City of Richmond

Report to Development Permit Panel

File: DP 17-772227

Re: **Application by Interface Architecture Inc. for a Development Permit at 11671 and 11691 Cambie Road**

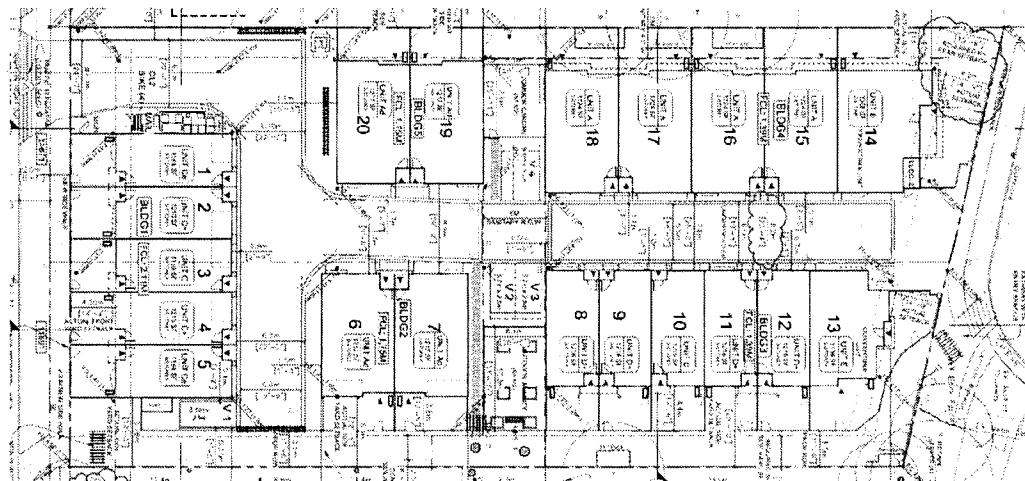
- consider extending the grey-coloured paved pedestrian walkway along the west edge of the entry driveway throughout the entire length of the internal drive aisle;

- consider a similar treatment along the east edge of the internal drive aisle;

The owner agrees to extending the grey pavers throughout the internal drive aisle (i.e. no asphalt on site).

Have done this. Site entry pavers extended to SROW, linking to PROP walkway.
